PROJECT: Boone Central Athletic Complex Phase 2 **PROJECT NO.** L13015.1
LOCATION: Albion, NE **DATE:** 09/05/13
ADDENDUM NO. 2

BOONE CENTRAL PS - ATHLETIC COMPLEX - PHASE 2

PARTIAL REVISED FOUNDATION PLAN

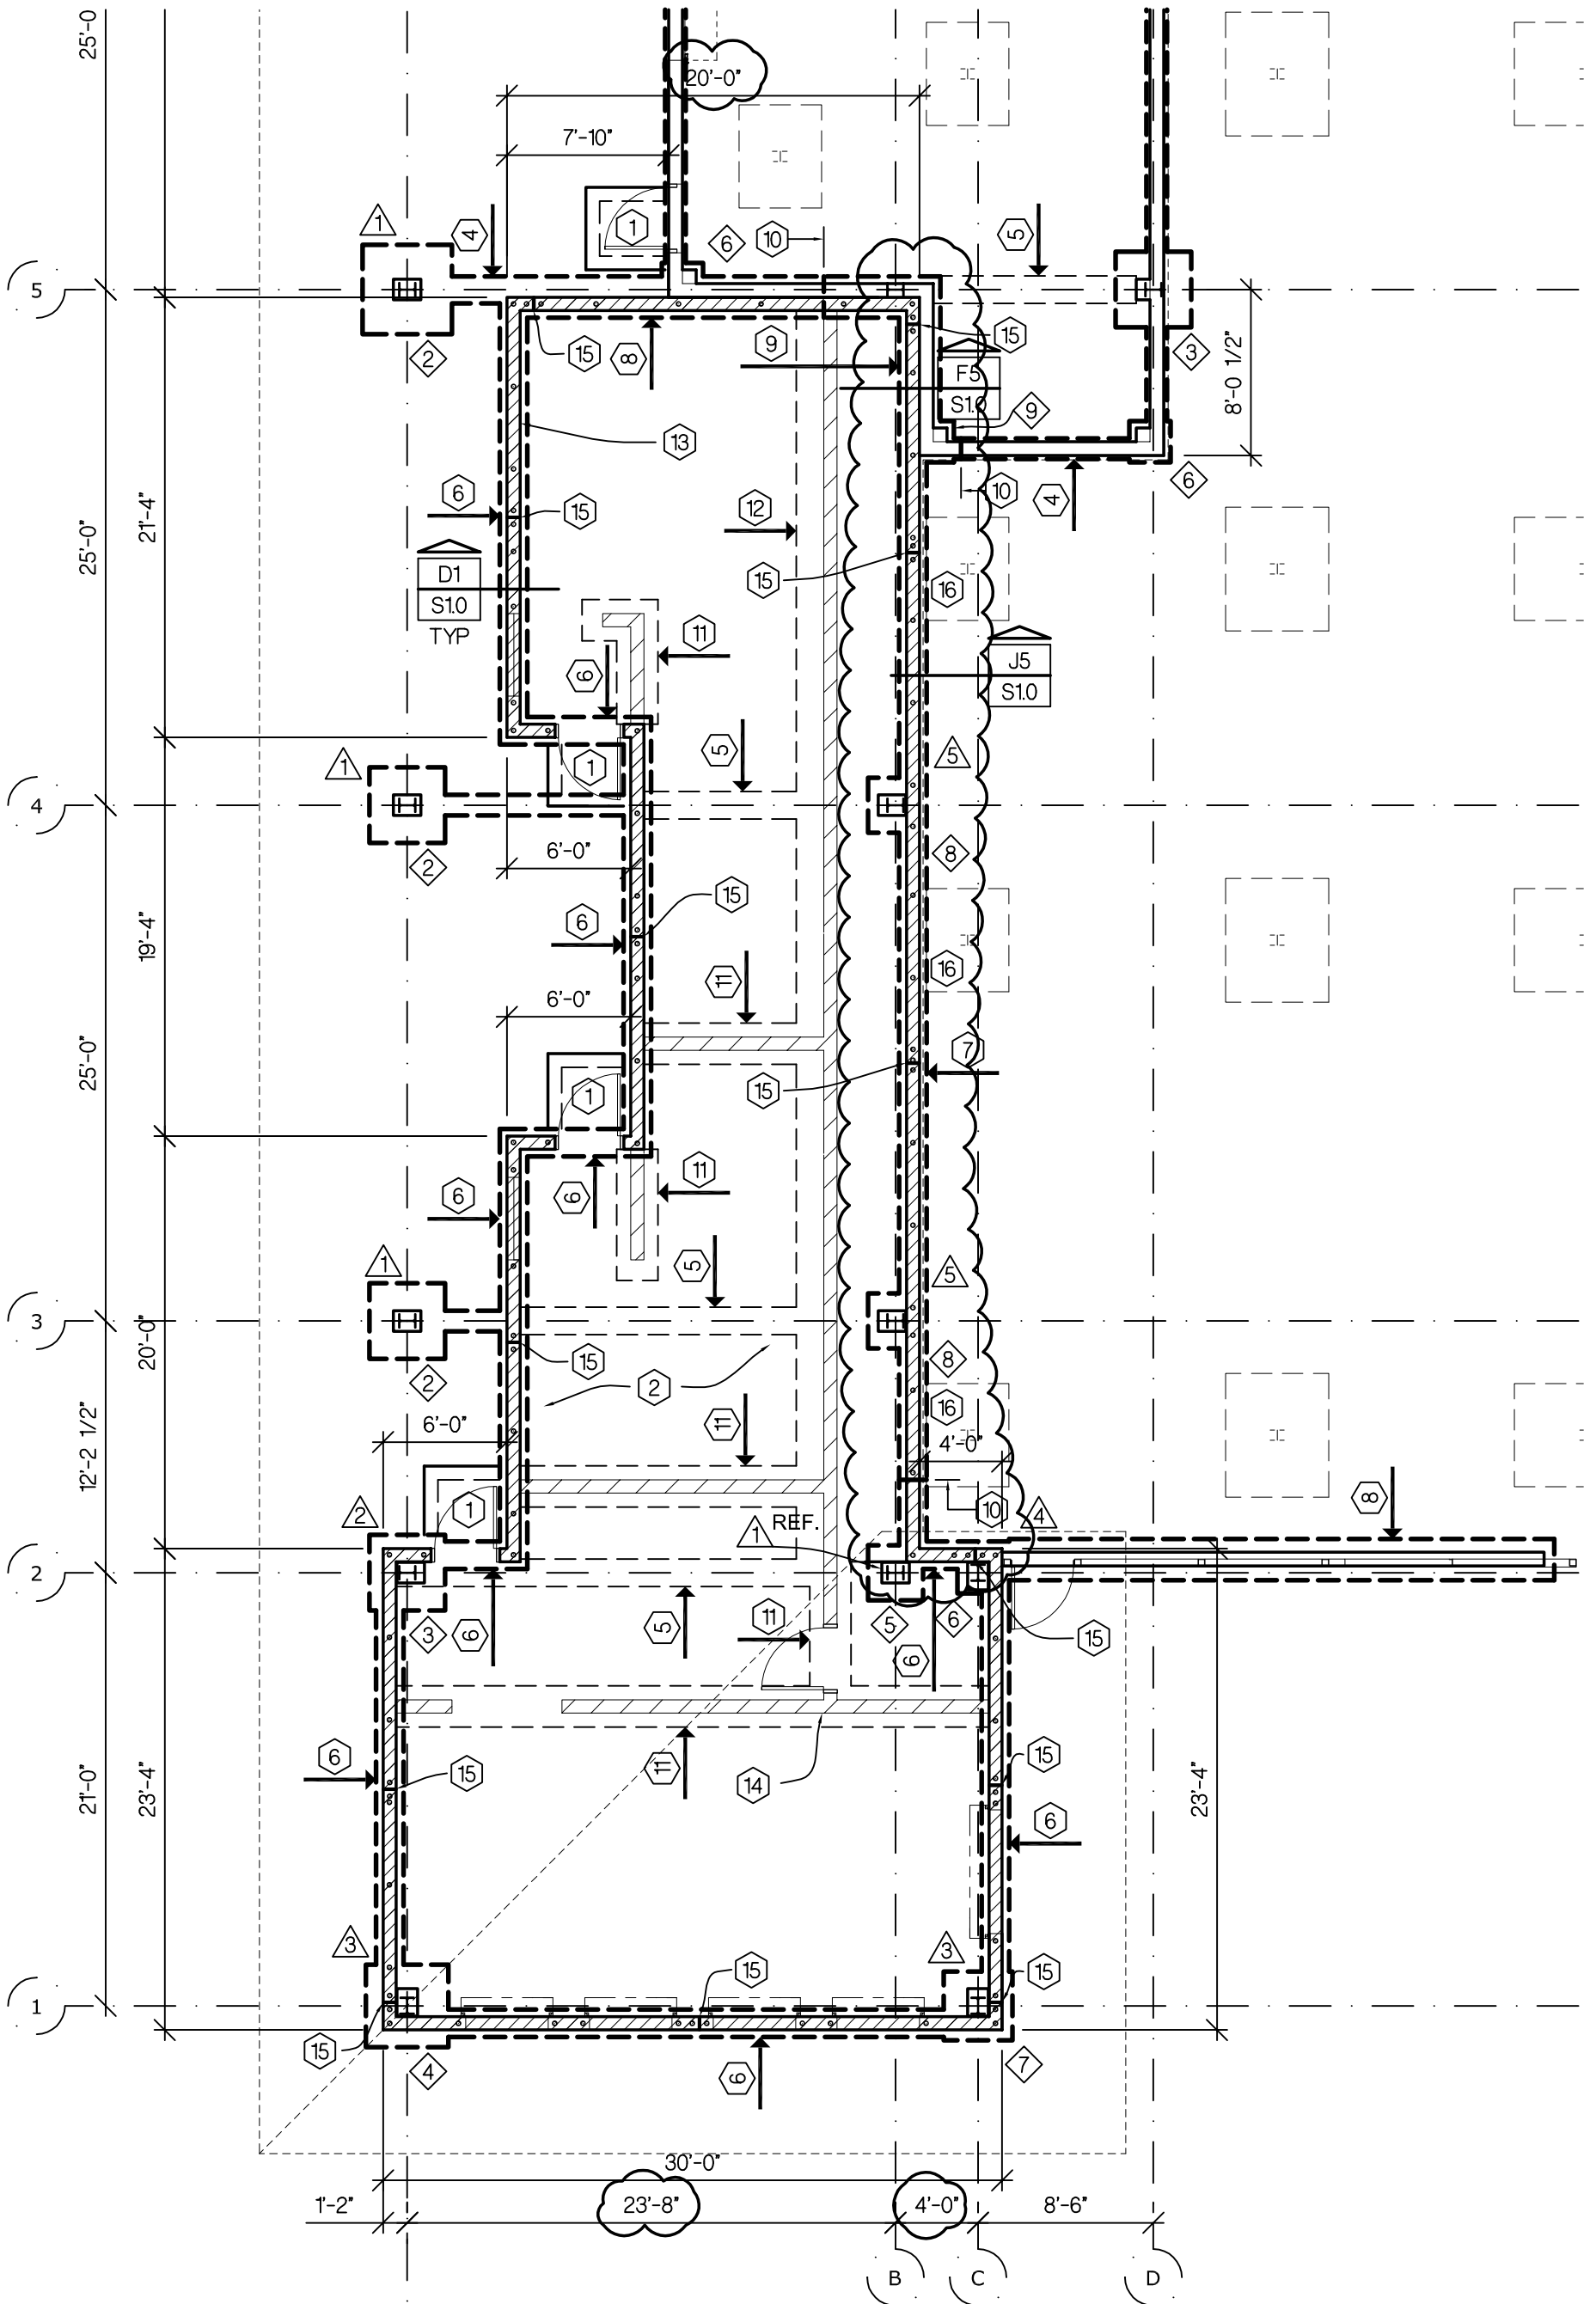
- Refer to sketch aS1 for foundation plan revisions. The plumbing chase wall was moved 2'-0" east.
- Refer to sketch aS2 for revisions to the plan notes relative to the foundation plan.
- Refer to sketch aS2 for revisions to the foundation plan at the ticket booth.
- Refer to sketch aS4 for revised detail H1/S1.0.

REVISED FRAMING PLAN AT CONCESSIONS AND RESTROOMS

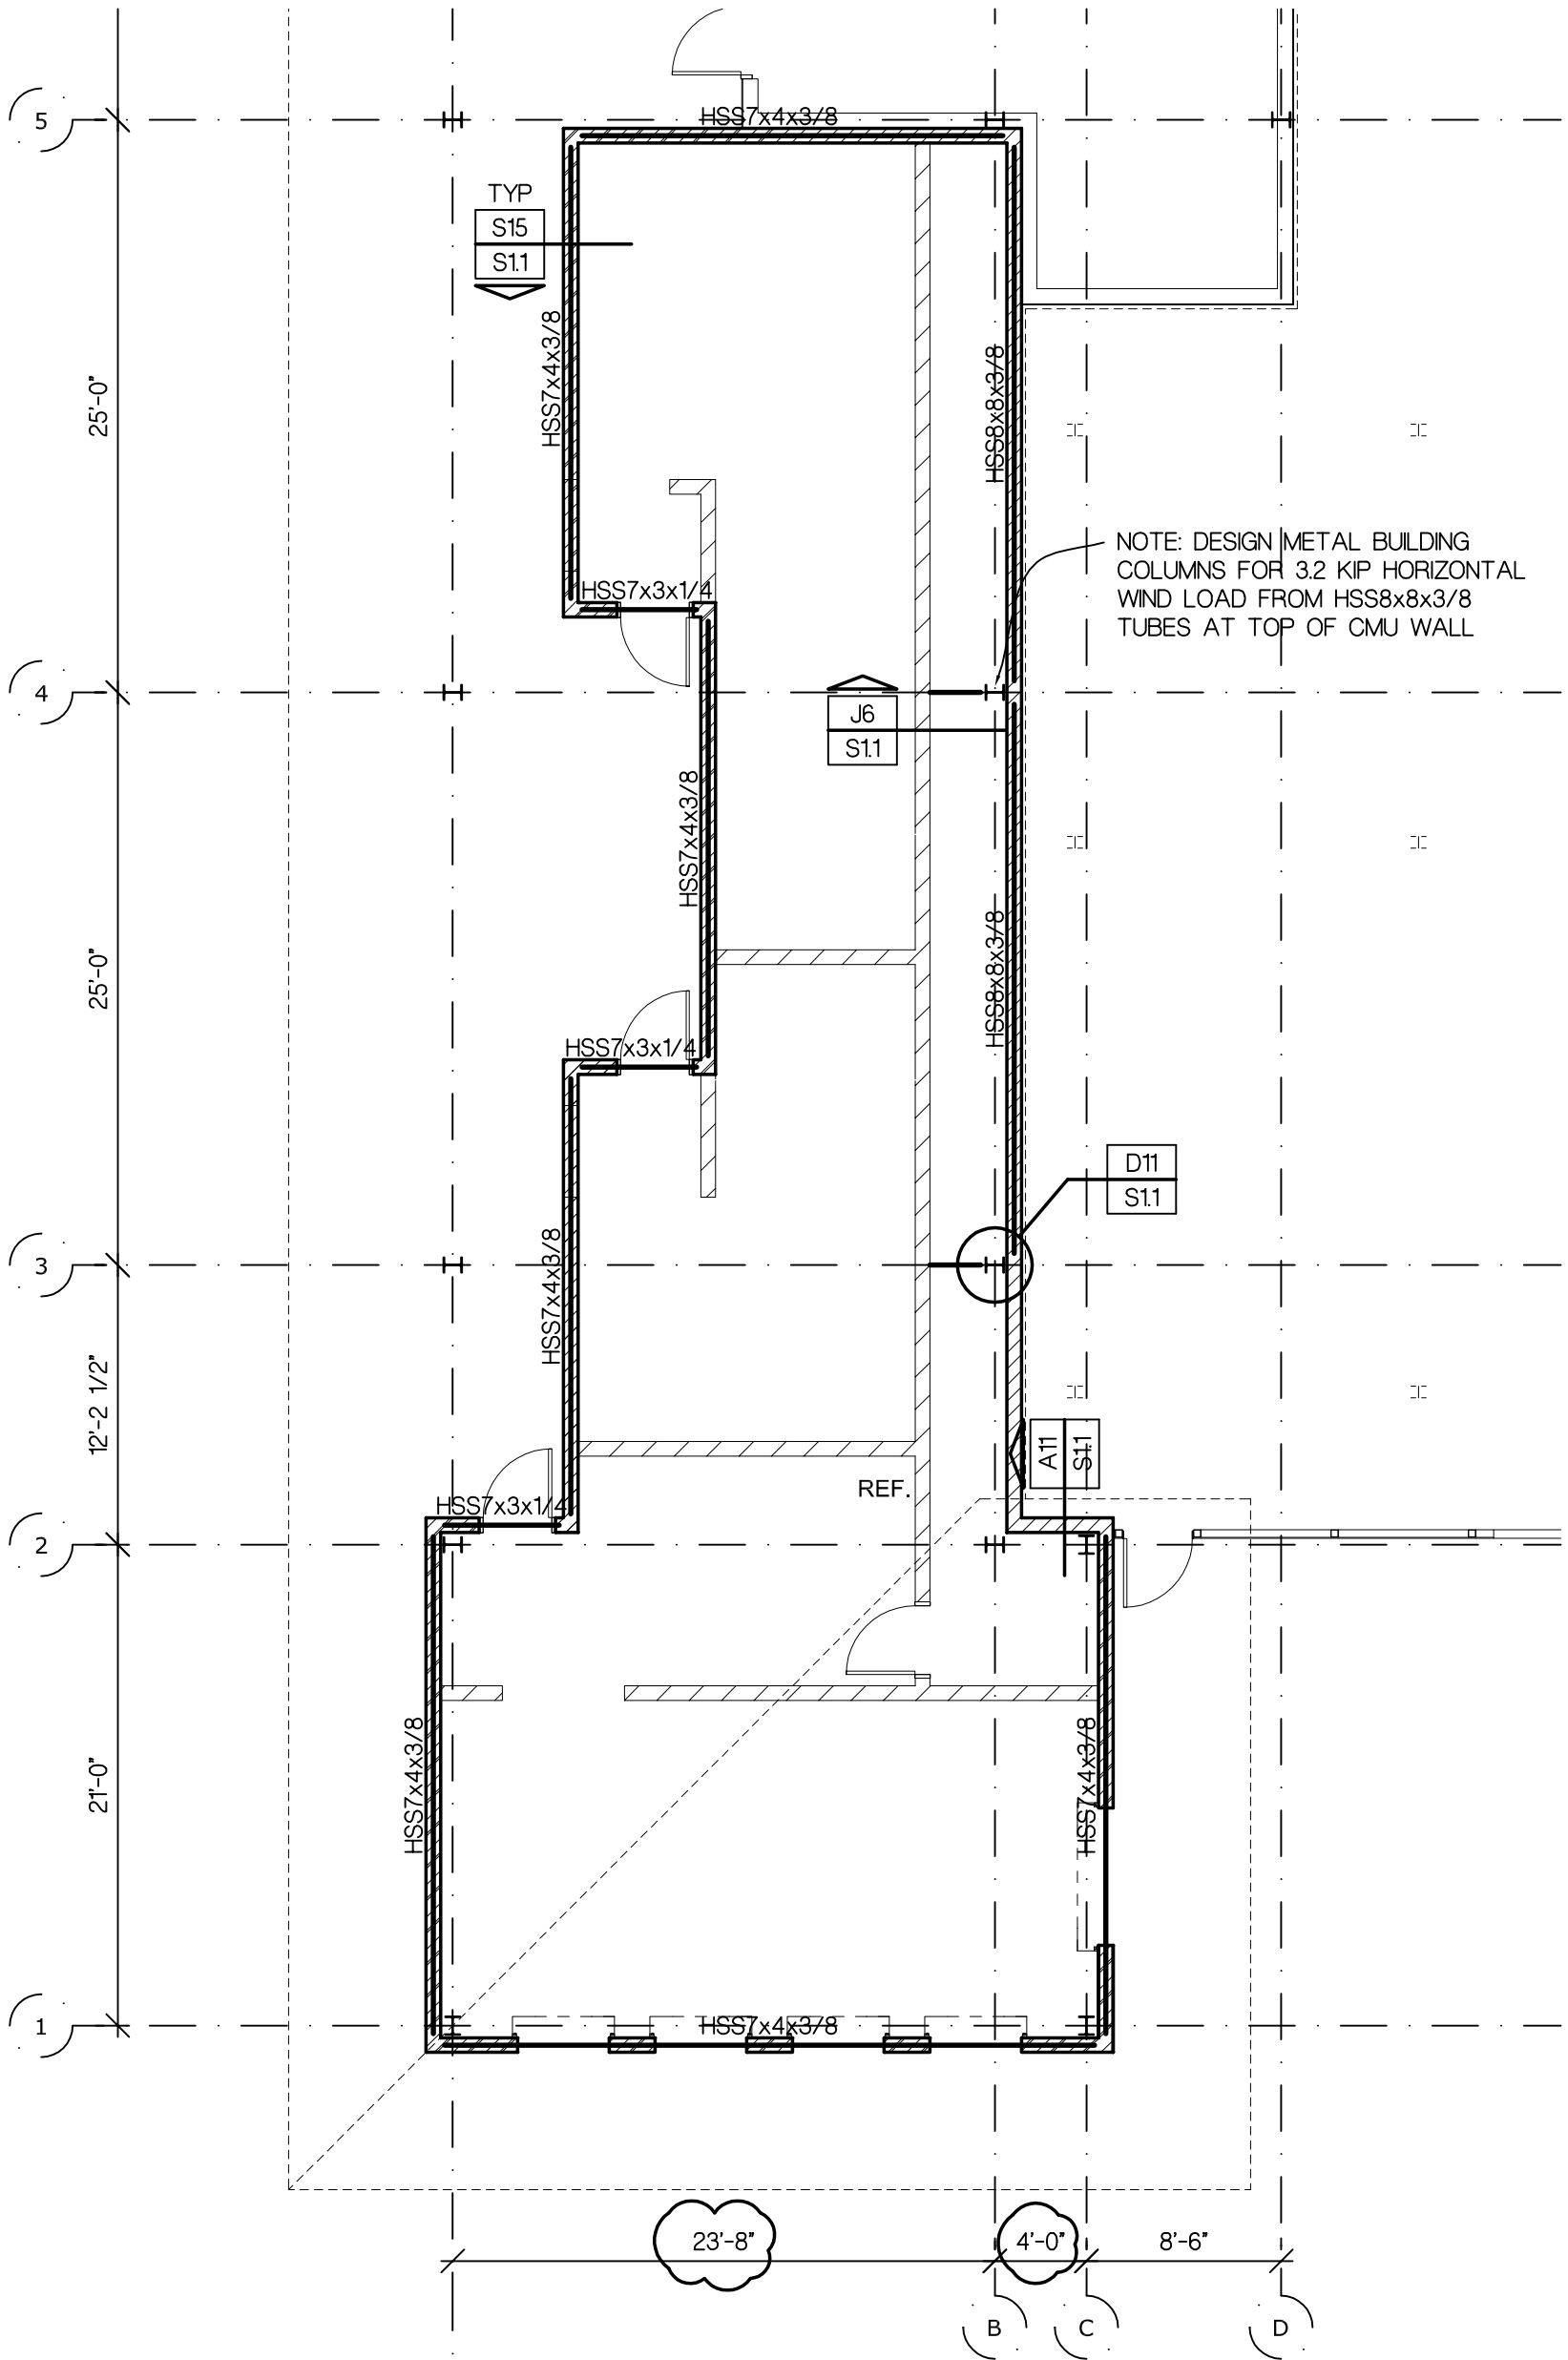
- Refer to sketch aS3 for revisions to the framing plan at concessions and restrooms.
- Refer to sketch aS5 for revised detail L11/S1.1.
- Refer to sketch aS6 for revised detail D11/S1.1.

GRADING PLAN

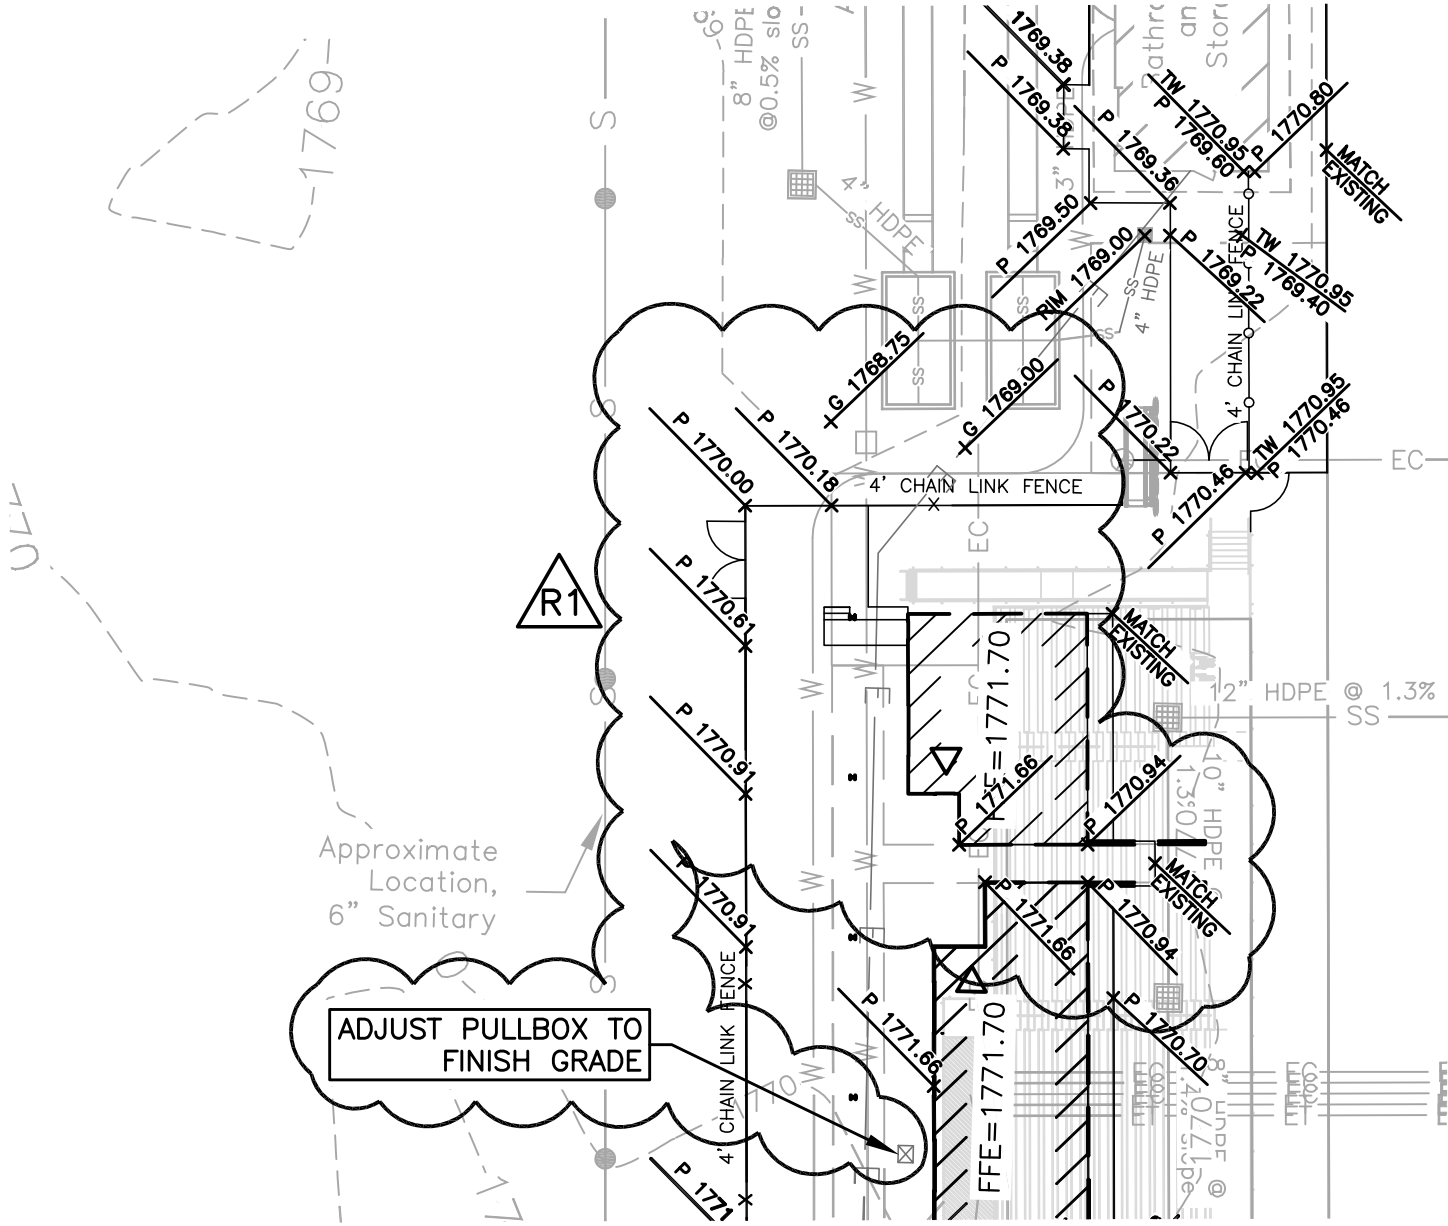
ISSUED FOR:	DATE:	BY:
REV. SPOT GRADES	09/05/13	NB

CONCRETE STAIR DETAIL

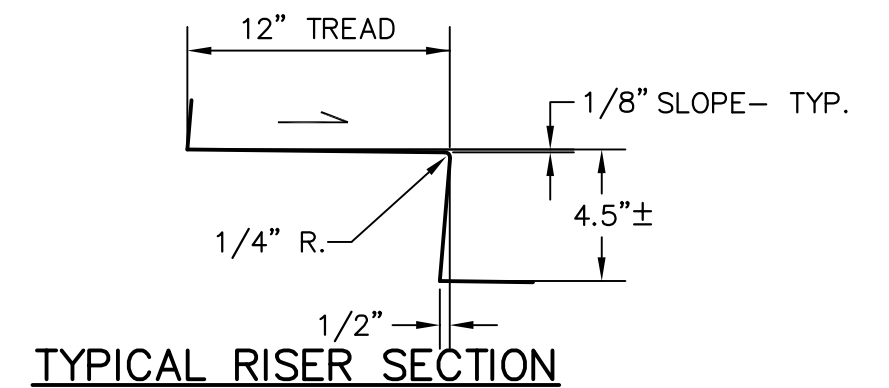
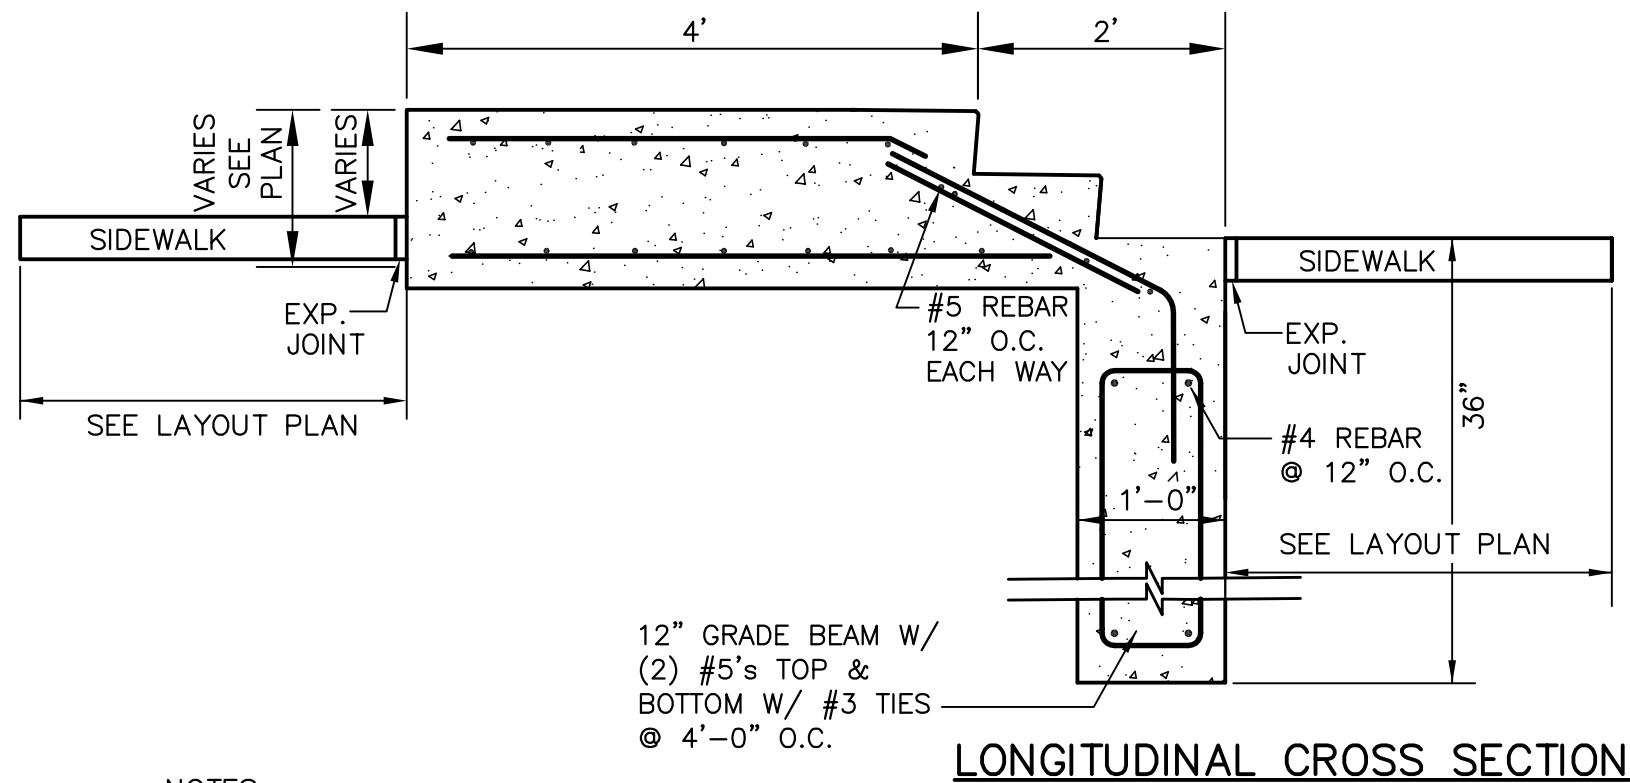
ISSUED FOR:	DATE:	BY:
ADDED CONCRETE STAIR DETAIL	09/05/13	SB
